Job # _____
 Date Sent: 1/9/09
 File # 1-2
 Appl. # 01-109875
 Addendum, Change Order, Drawing, Deferred Approval, Worksheet and Transmittal Memo (Jachan)

APPENDUM NO. 1

Chabot College Modernization
of Buildings 300 and 500
Chabot-Las Postas Community College District
HMC # 3342002, DSA #01-109151

November 21, 2008

ADDENDUM #1
 Scale as shown
 Project No. 3342002
 Date 11/21/08
 Ref. sheet No.
 Drawing No. AD1-A9
 2/A8.1_B

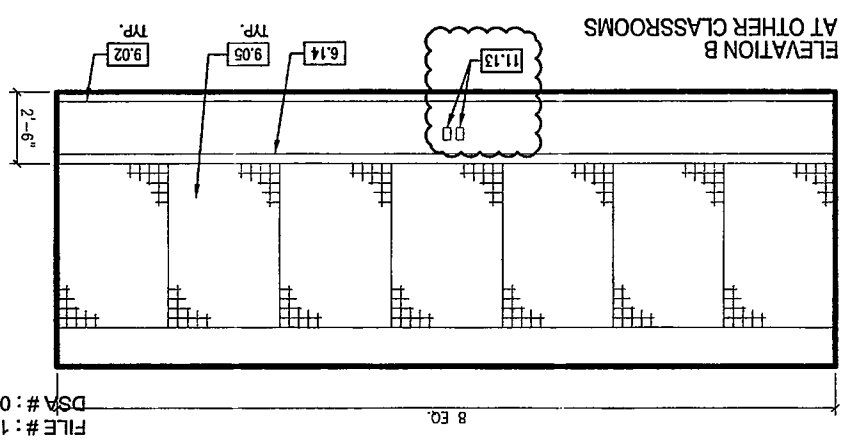
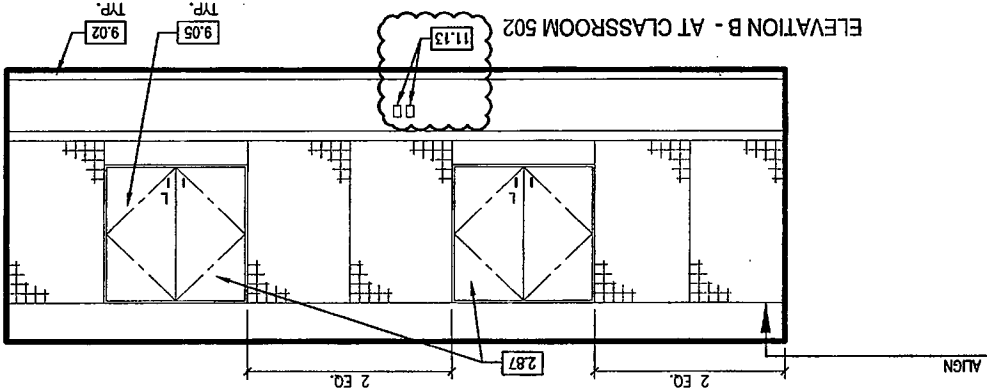
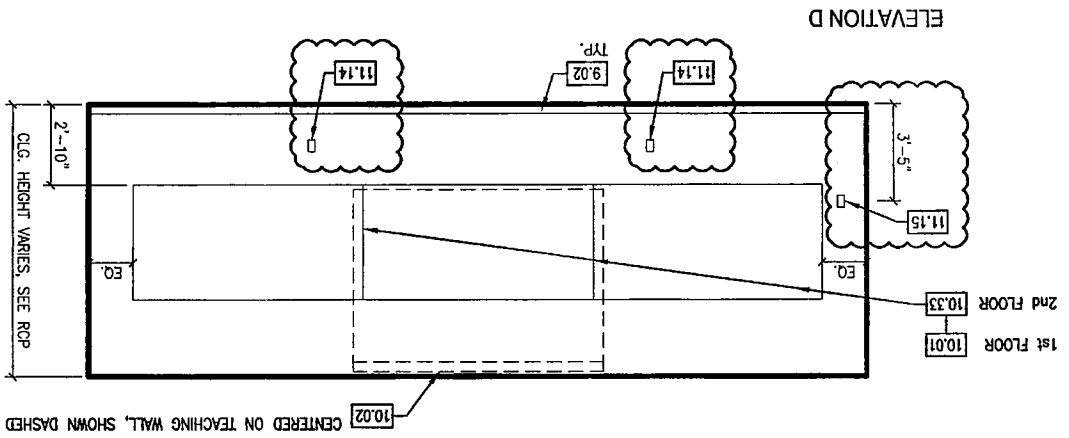
A. On Detail No. 1, Revise Keynote "#10.03" to "#10.05" on Sheet Border - Interior Elevation Keynotes and on Detail No. 1.

B. Revise Keynote # 10.05 to read as follows:

C. On Detail No. 3, Add locks to casework that did not already have locks indicated. All Casework to receive locks except Casework Type D, Accessible Base Sink - Cabinet.

D. On Detail No. 1, Revise Keynote # 11.11 on Sheet Border to read as follows:

"Display Board, 4'-0" x 8'-0". See Detail 16/A10.9."

"Future recessed 32" flat screen display location. Provide power and data as indicated on Electrical and Telecommunication Drawings. Provide recessed opening with blocking. See Detail 7/A10.9."

ADDITIONUM # 1	
Project No. 3342002	Scale 1/8"=1'-0"
Date 11/21/08	Ref. sheet No.
Drawing No. AD1-A11	7/A10.9

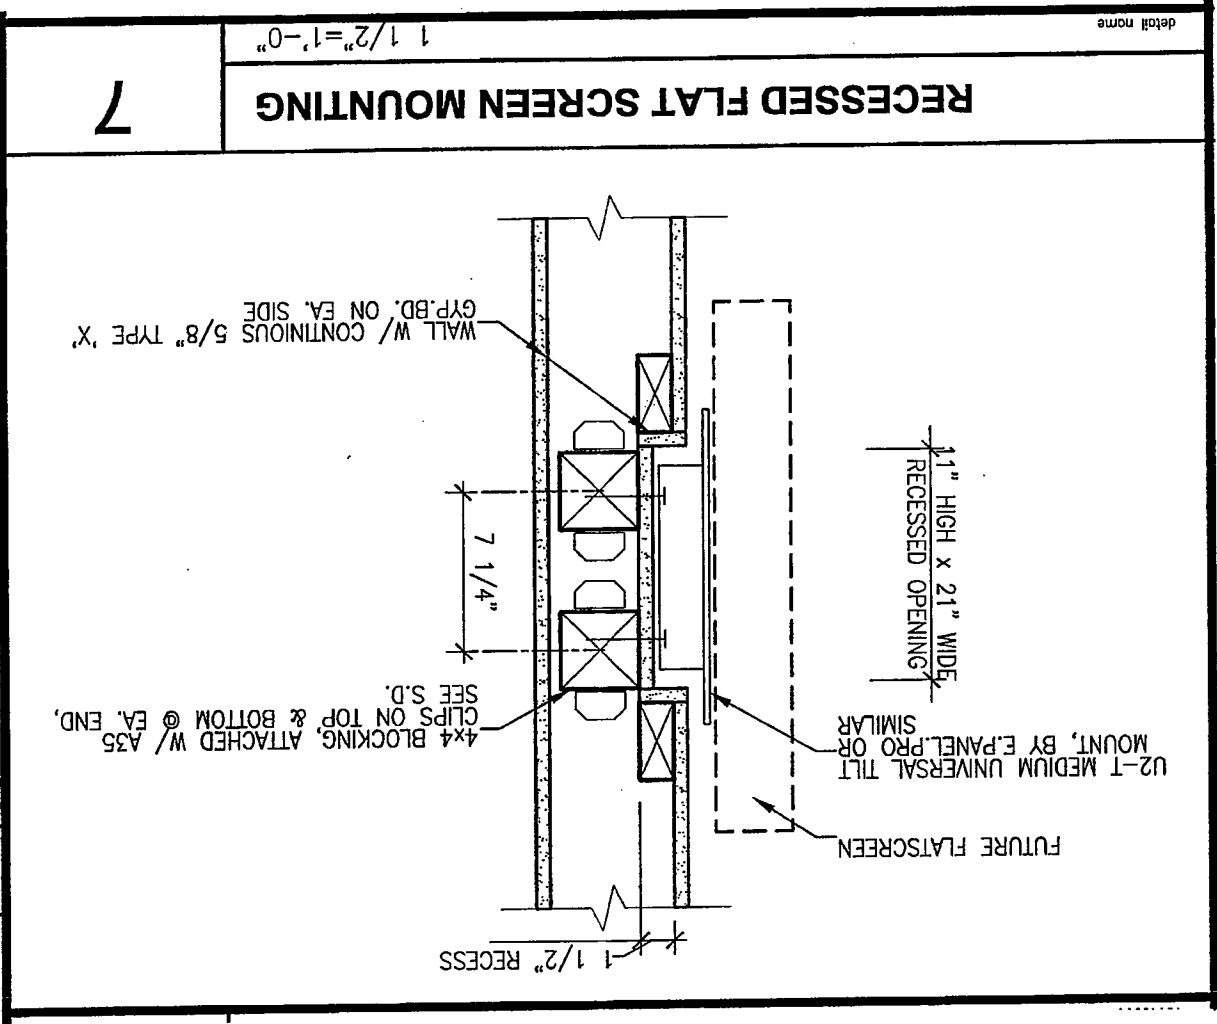
- AD1-A1 through AD1-A10
- AD1-A11 (new Detail 7 on A10.9)
- AD1-A12 (new Detail 11 on A10.9)
- AD1-A13 through AD1-A16
- AD1-A17 (new Detail 12 on A10.10)
- AD1-A18 (new Detail 13 on A10.10)
- AD1-S1

Scale: 1/8" = 1'-0"
 Ref. Detail No.
 Project No. 3342002
 Date 11.21.08
 Drawing No. AD1-51
 S2.6

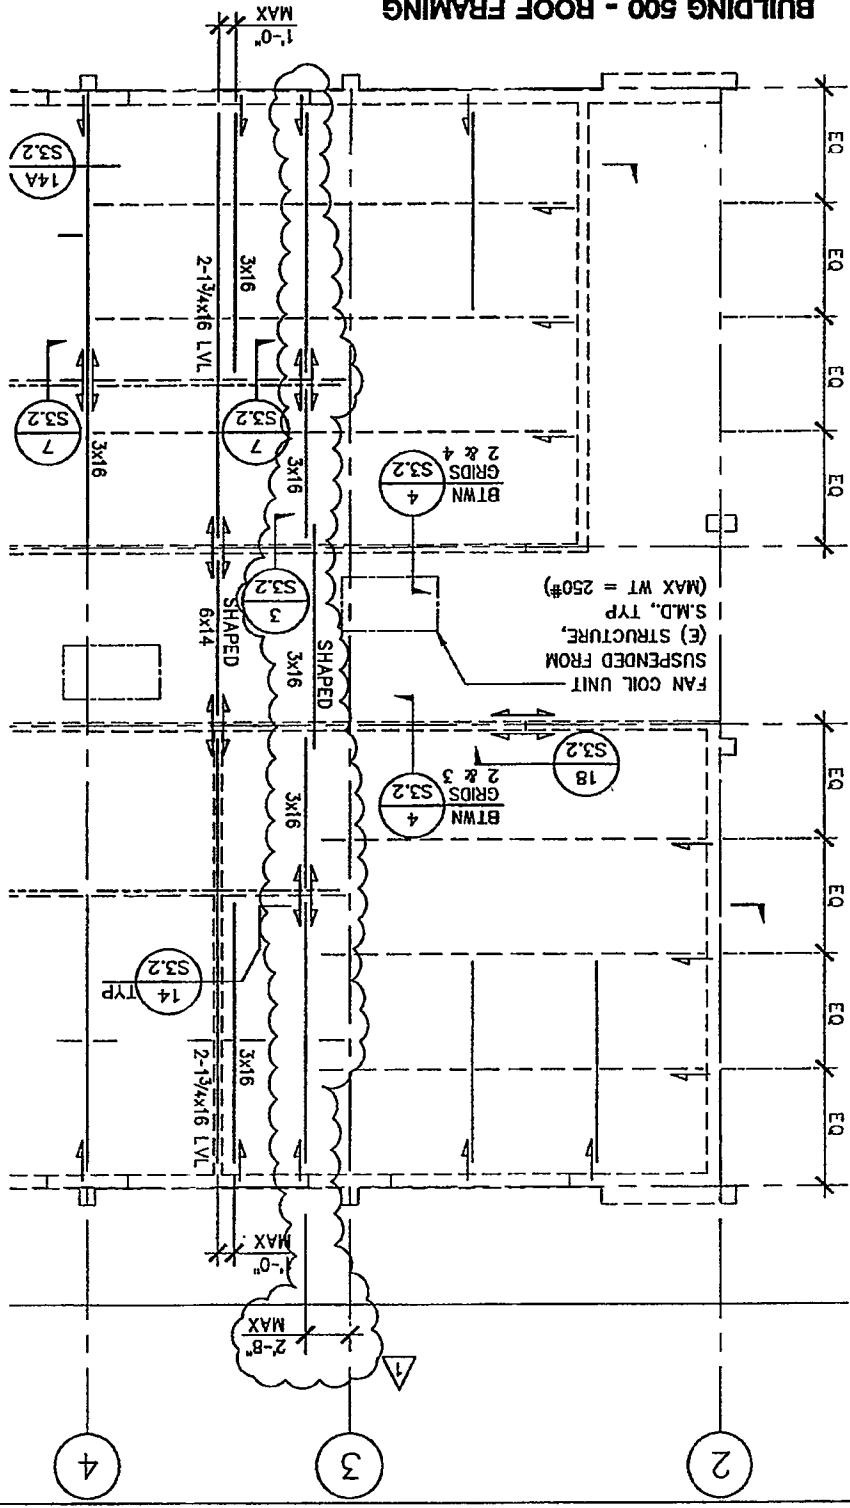
**BUILDING 500 - ROOF FRAMING
 PARTIAL PLAN**

CHECK BENT # SPICE PER DETAIL "/s3.2

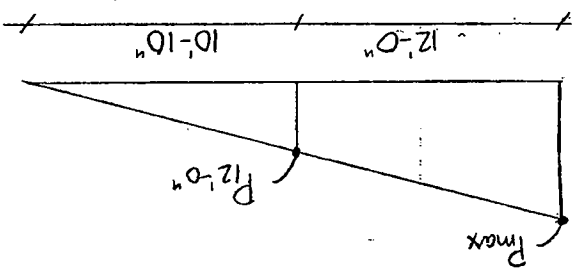
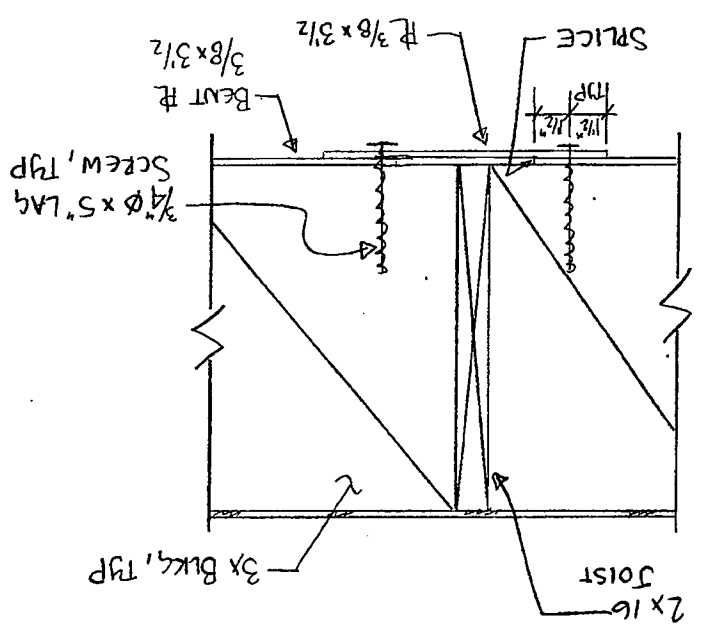
CHECK 1/2" LAG SCREW TO TRANSFER LOAD FROM ONE # TO ANOTHER #:

Splice is located 12'-0" from exterior wall minimum

$$DCR = 0.961 < 1.0 \quad \underline{\underline{OK}}$$
